# Safety Evaluation Report

Related to Renewal of the Facility Operating License  
for the University of Massachusetts Lowell Research  
Reactor

License No. R-125  
Docket No. 50-223

February 2022

**Figure 2-10 PLTEMP Power-to-Flow Map at ONB**

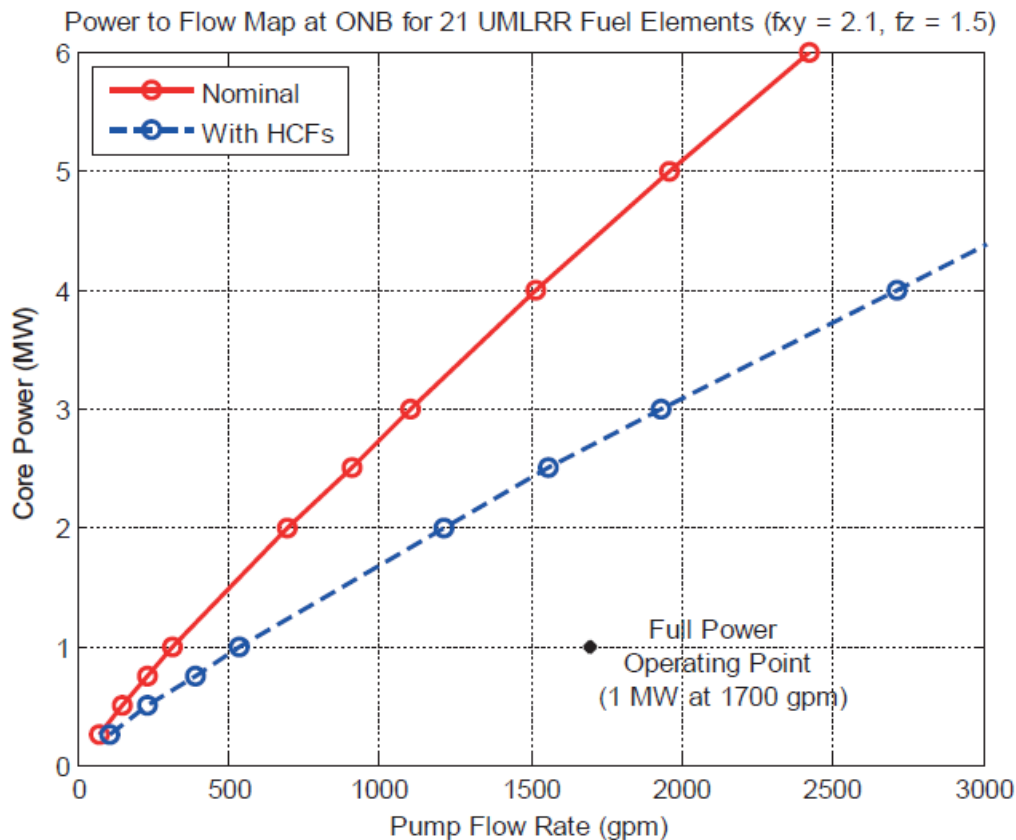
UML's PLTEMP power-to-flow map is shown in SER Figure 2-10 (taken from SAR Figure 4-17). The power-to-flow map identifies, for a given power level, what total pump flow rate would lead to ONB conditions in the hot channel. The map illustrates that at nominal power and flow conditions, or LSSS power and flow conditions, there is a large margin to ONB (regardless of whether hot channel factors are conservatively applied). All calculations for the map conservatively assume a pool inlet temperature of 110 °F (43.3 °C), slightly above the LSSS setpoint.

**Figure 2-11 Case 1 Axial Temperature Profiles**

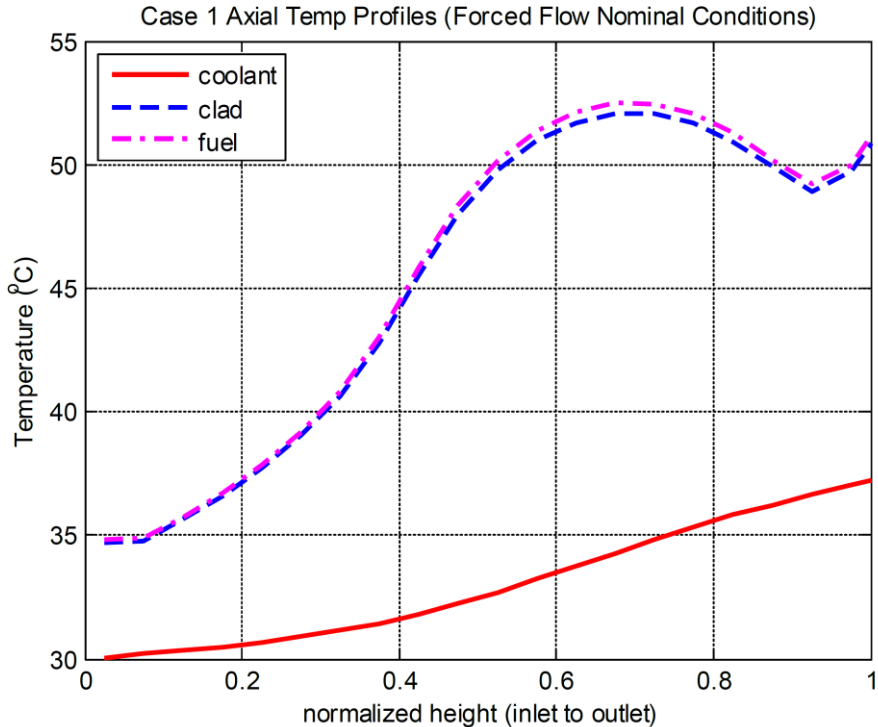
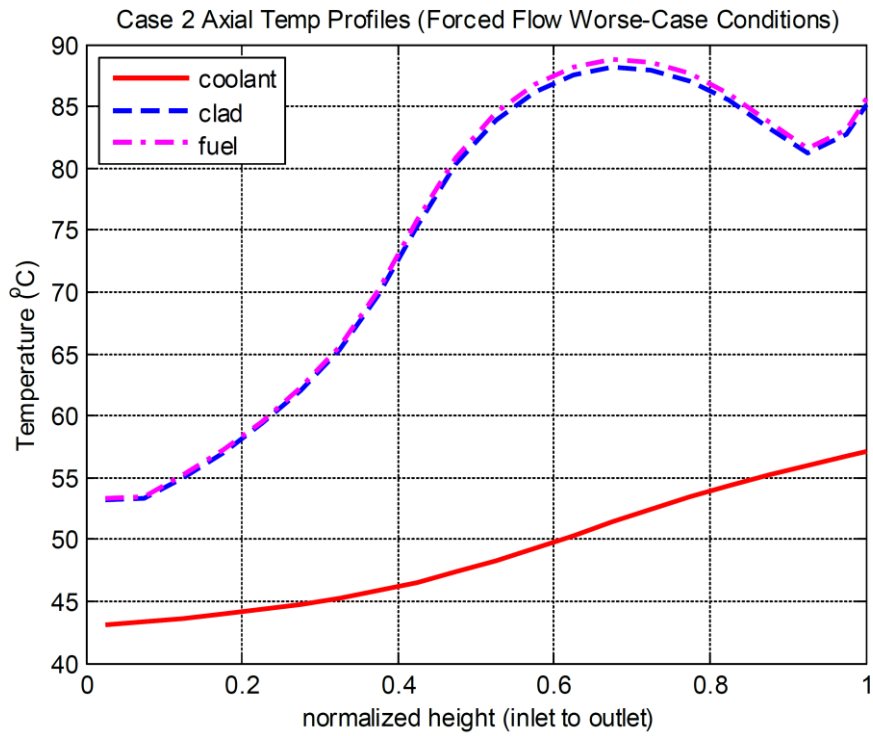
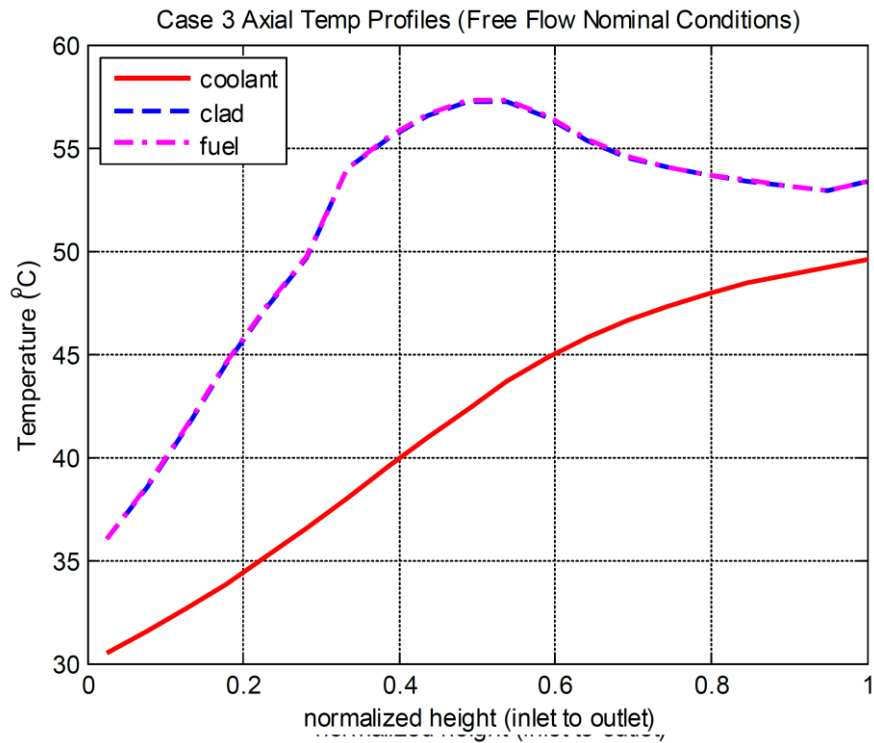
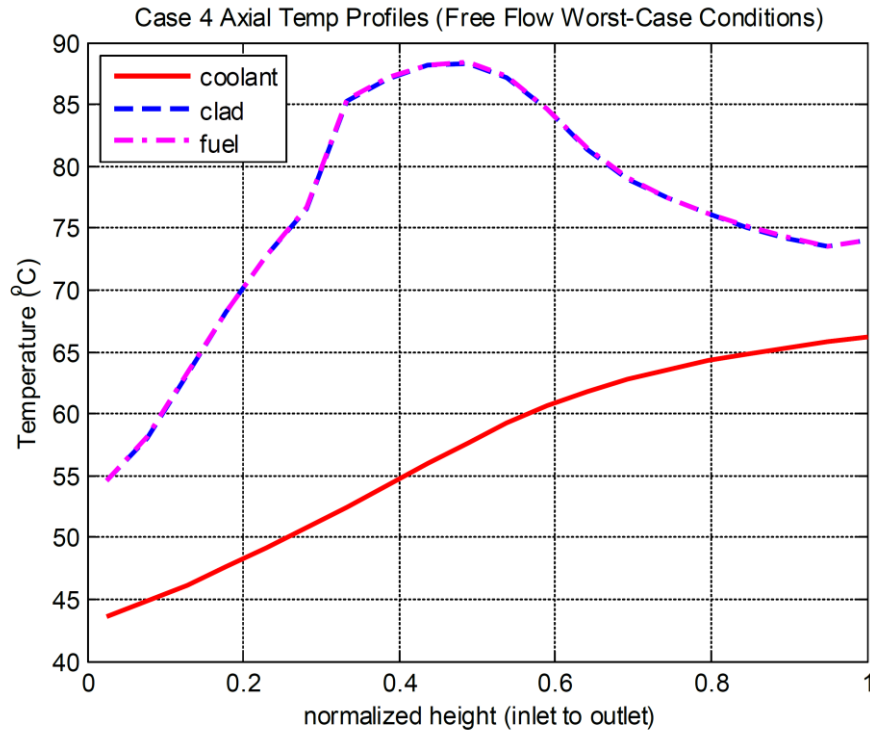
The above axial temperature profiles indicate that for steady-state UMLRR operation, at nominal or beyond-LSSS conditions, the fuel and cladding temperatures remain well below both the TS 2.1 SL and the minimum ONB threshold of 118 °C (244 °F), confirming a large margin to ONB or possible fuel failure for any routine condition of forced flow or natural convection operation.

**Figure 3-9 Proposed Instrumentation Panel Layout**

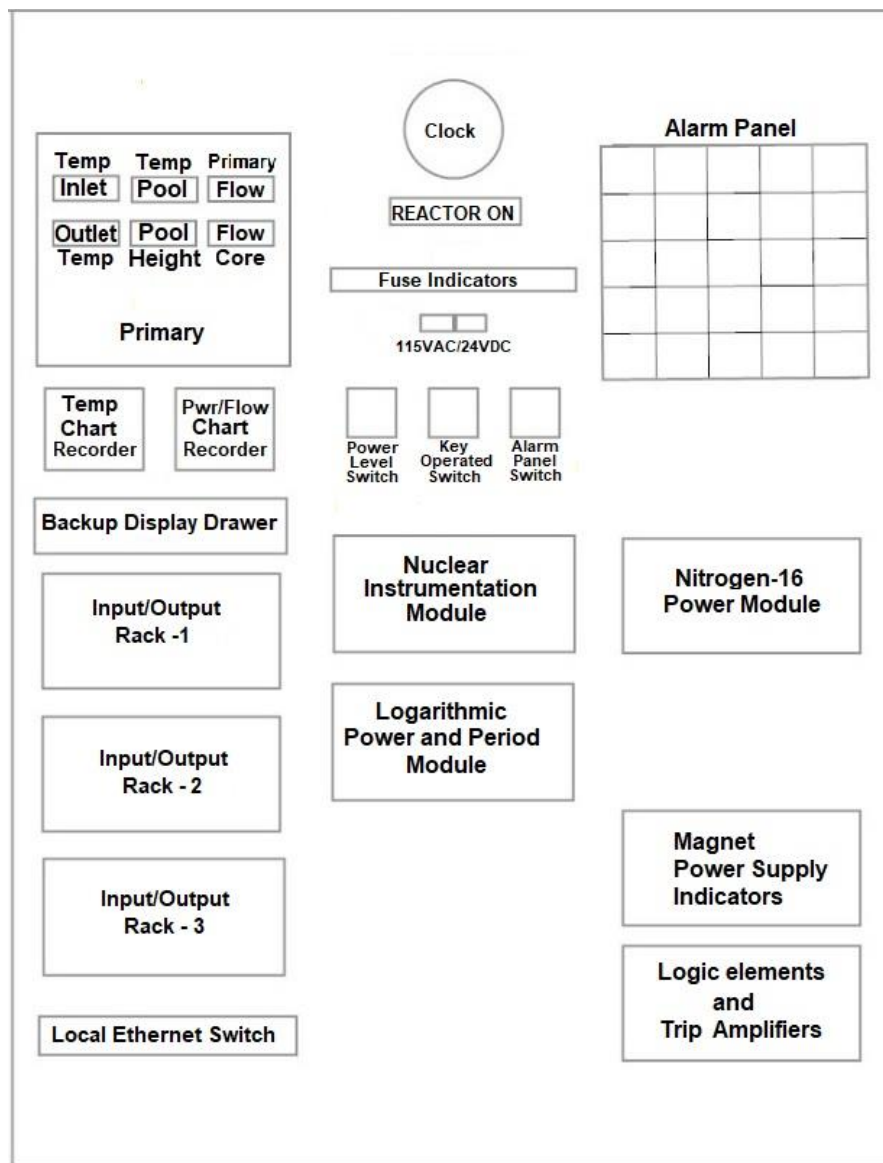
As is shown in SER Figure 3-7, the instrumentation panel is located in the control room adjacent to the control console and angled toward the operator to facilitate viewing of and access to the instrument readouts and controls. The proposed layout of the UMLRR instrumentation panel is shown in SER Figure 3-9, which is reproduced from SAR Figure 7-8. As discussed in SAR Section 7.3.3, the key operated switch (also referred to as the master key switch or the master control switch) on the instrumentation panel prevents unauthorized reactor operation because

As described in SAR Section 7.1.6 and SAR Table 7-7, two chart recorders are mounted in the instrumentation panel (see SER Figure 3-9). The temperature chart recorder records primary coolant inlet temperature (i.e., pool inlet temperature; see SER Sections 2.5.3 and 3.4.1), outlet temperature (i.e., core outlet temperature), and pool temperature (i.e., bulk pool temperature). The power and flow chart recorder records reactor power and primary coolant flow rate. In its renewal application, UML proposed that the recorder inputs be modified to record indicated power of the proposed GA Gen-2 NMP-1000 Linear Power Module 1 (as stated in SAR Table 7-7) and the proposed TFS log PPM (as stated in UML’s updated SAR Section 7.4.1.2 (Ref. 73)). Renewed TS 3.2.5, which is discussed and found acceptable in SER Section 2.5.3, only requires that one of the two linear power channels be operating and, therefore, Linear Power Module 1 is not strictly required to be operating. However, the log PPM is always required to be operating by TS 3.2.5 when the reactor is operating; therefore, the output from at least one power monitoring channel will be recorded by the power and flow chart recorder while the reactor is operating.

**Figure 5-1 Step Insertion of 0.6%  $\Delta k/k$  for Forced Flow and Initial Power of 0.01 Watt-thermal**

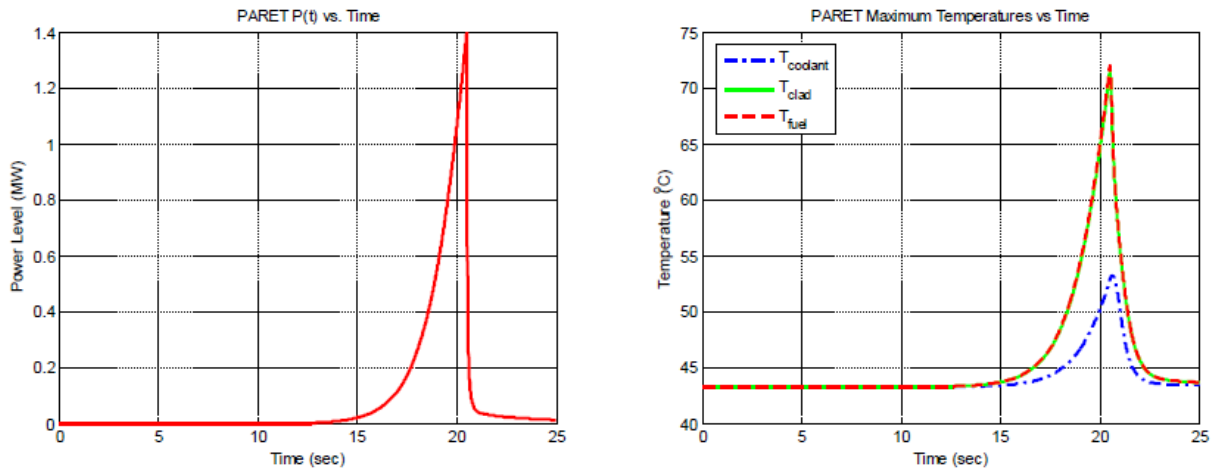
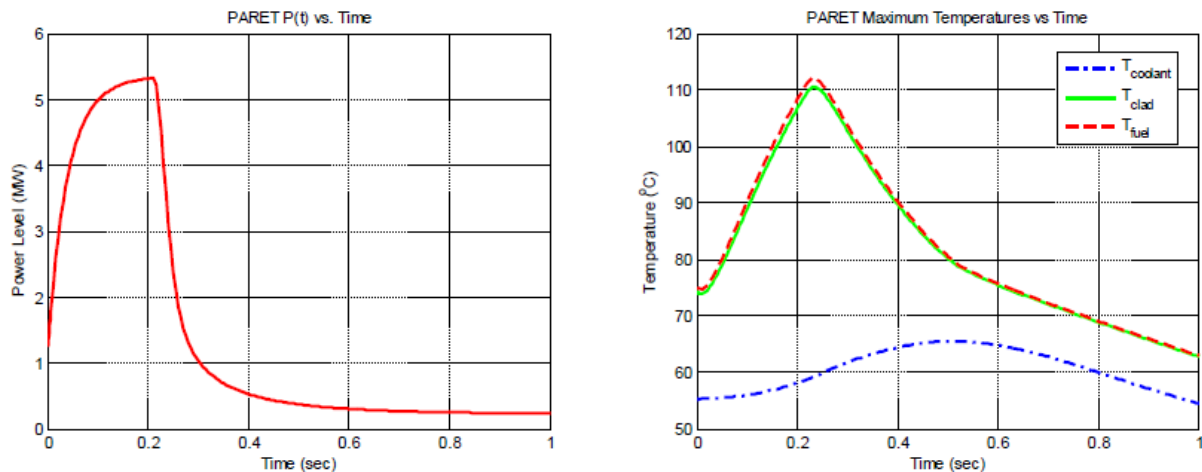
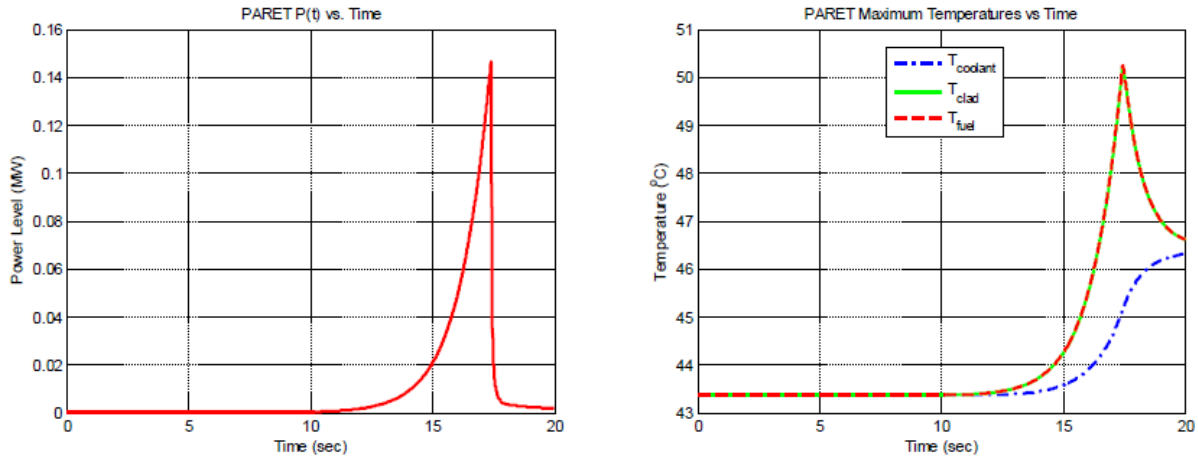
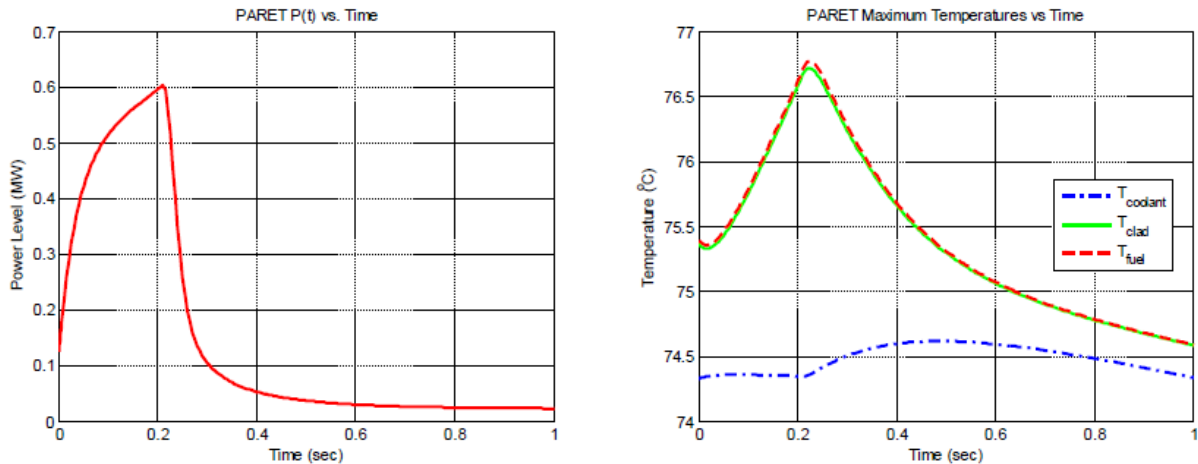
The figures show that for all four scenarios, the maximum fuel cladding temperature remains below the minimum onset of nucleate boiling (ONB) threshold of 118 °C (244 °F) and well below the TS 2.1 safety limit (SL) of 530 °C (986 °F). UML stated that its analyses show that ONB does not occur for any of its step insertion scenarios. In the worst-case step insertion scenario, for forced flow operation and initial reactor power of 1.25 MWt (SER Figure 5-2), the maximum cladding temperature reached is approximately 111 °C (232 °F) and the maximum reactor power level reached is approximately 5.3 MWt.

The NRC staff reviewed the results of UML's step reactivity insertion analyses, discussed above. The NRC staff finds that the results of the analyses demonstrate that credible rapid reactivity insertion accident scenarios (e.g., experiment failures) at the UMLRR would result in maximum fuel cladding temperatures that are well below the SL and temperatures at which fuel failure could occur. Therefore, the NRC staff finds that the results of UML's step reactivity insertion analyses are acceptable.

**Figure 5-9 NRC Staff Confirmatory Calculation of Ramp Insertion of 0.05%  $\Delta k/k$  per second for Forced Flow and Initial Power of 0.01 Watt-thermal**

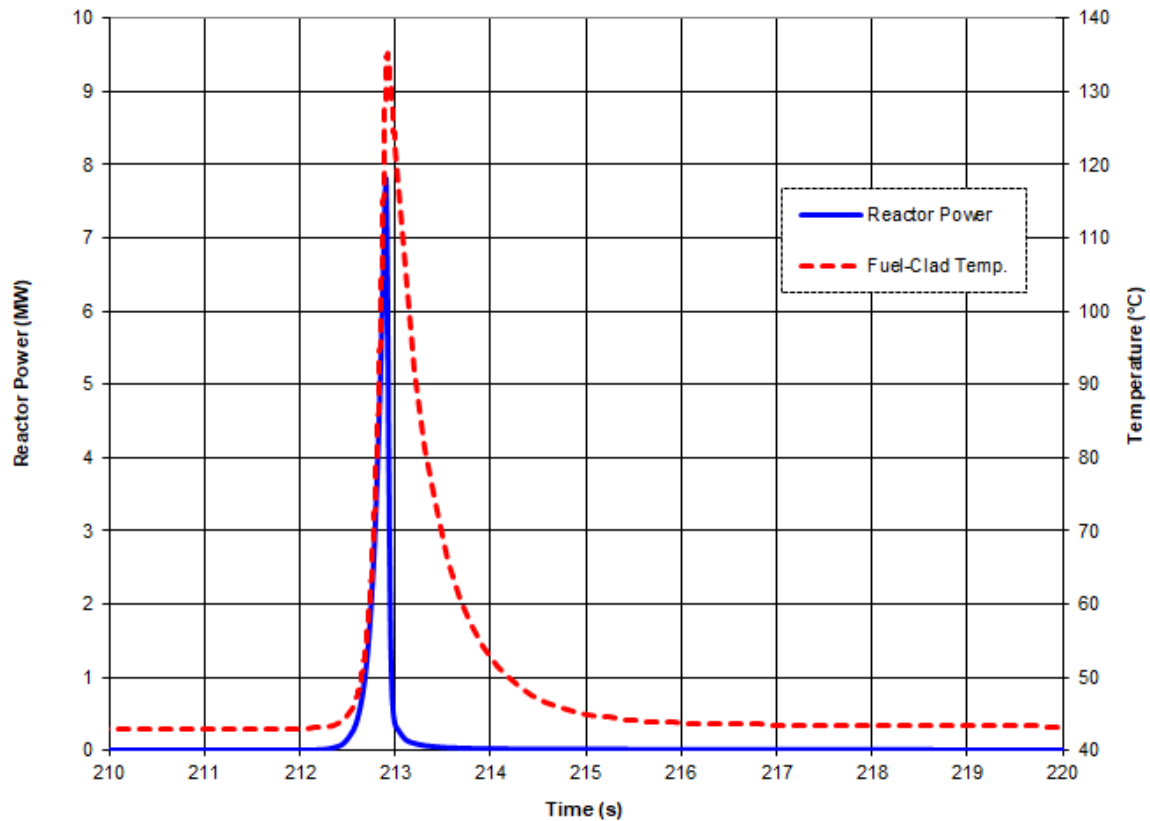
The results of the NRC staff's confirmatory calculation are shown graphically in SER Figure 5-9, which shows plots of reactor power and fuel cladding temperature versus time. For the calculation with results illustrated in Figure 5-9, the maximum cladding temperature is approximately 135 °C (275 °F) and the maximum reactor power is approximately 7.8 MWt.

In addition, the NRC staff performed a second calculation that is similar to its calculation discussed above and illustrated in Figure 5-9, except that the NRC staff conservatively ignored all reactivity feedback effects. For its second calculation, the maximum cladding temperature reached is approximately 142 °C (288 °F) and the maximum reactor power is approximately 13.2 MWt.

The NRC staff notes that, for both NRC staff calculations (with and without reactivity feedback), the maximum cladding temperature exceeds the minimum ONB threshold of 118 °C (244 °F). The NRC staff also determined that ONB conditions would be reached. However, the results of the NRC staff's calculations, even when reactivity feedback is ignored, are well below the TS 2.1 SL of 530 °C (986 °F). Both NRC staff calculations additionally demonstrated that although nucleate boiling could very briefly occur, departure from nucleate boiling conditions (i.e., departure from nucleate boiling ratio > 2.0) would not be reached, indicating that bulk boiling could not occur. The NRC staff notes that, although its calculation used some inputs that were less conservative than those used by UML for its similar calculation of a ramp reactivity insertion during forced flow operation starting from low power, the NRC staff's calculated maximum cladding temperature (approximately 135 °C (275 °F)) was greater than UML's calculated maximum cladding temperature (approximately 120 °C (248 °F)). However, the NRC staff finds that this variation is likely due to other differences in the methodologies and assumptions used

**Figure 5-14 Peak Fuel Cladding Temperature versus Time for NRC Staff LOCA Fuel Integrity Confirmatory Analysis**

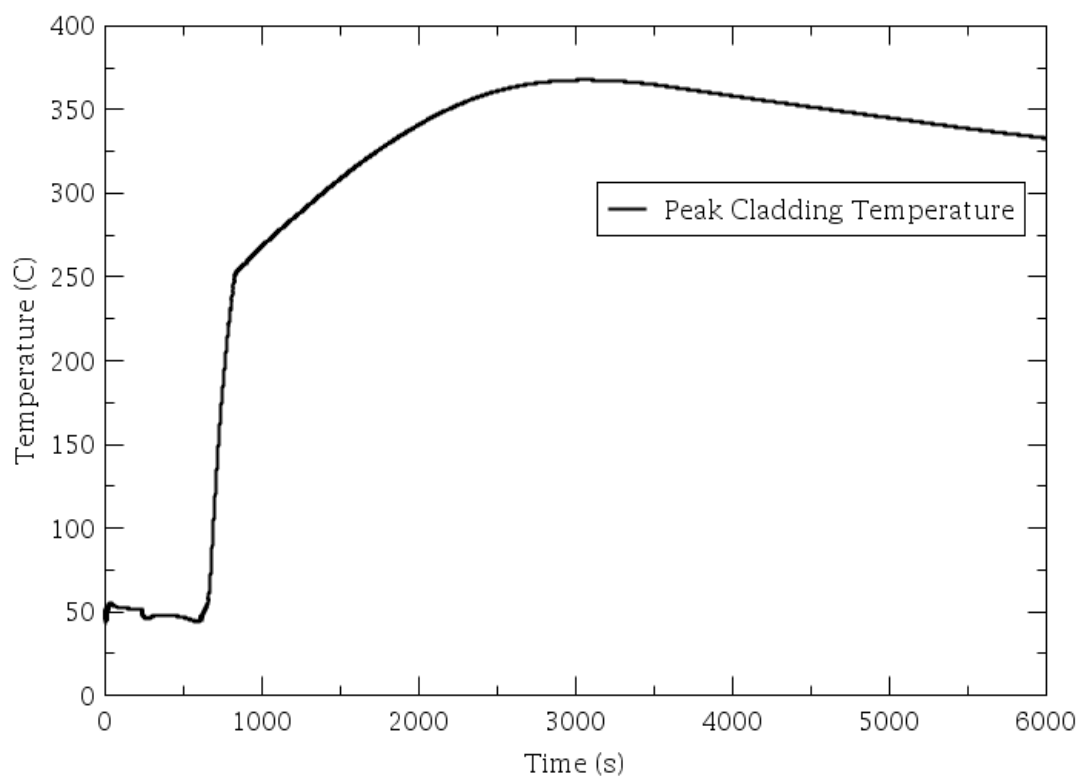
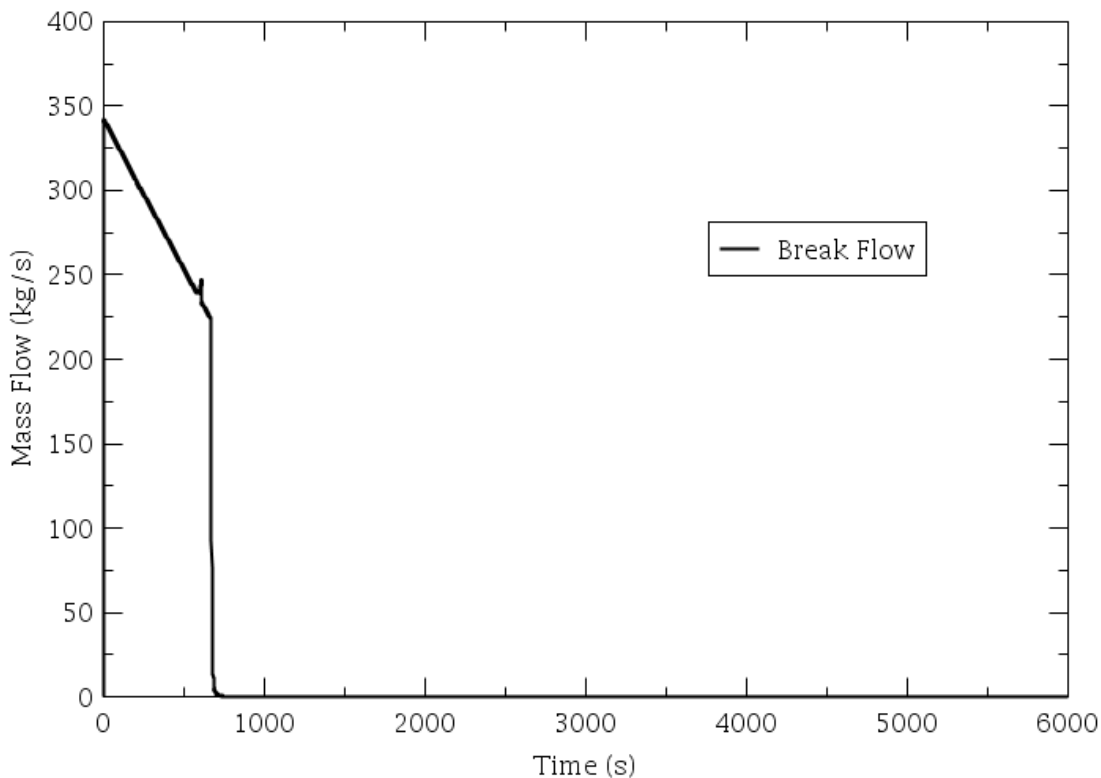
The results of the NRC staff's LOCA fuel integrity calculations are illustrated in SER Figure 5-14 and Figure 5-15 below. Figure 5-14 shows the peak cladding temperature versus time following the reactor scram. Figure 5-15 shows the mass flow rate of coolant out of the pool versus time following the reactor scram.

The NRC staff's analysis determined that, for an 8-inch diameter break, the maximum fuel cladding temperature is approximately 367.7 °C (693.9 °F), which is well below the SL and temperatures at which fuel cladding failure could occur. The pool drains much more quickly than in UML's analysis, given the larger break size. The analysis shows that the cladding temperature remains relatively low and constant while the pool is draining, then increases to a maximum after a portion of the fuel becomes exposed. For the 8-inch diameter break, the maximum temperature is reached approximately 3,038 seconds after the scram. (The NRC staff notes that, because the RINSC and UML analyses discussed above are based on a steady-state solution, they are independent of, and do not calculate, the time at which the maximum temperature occurs.)
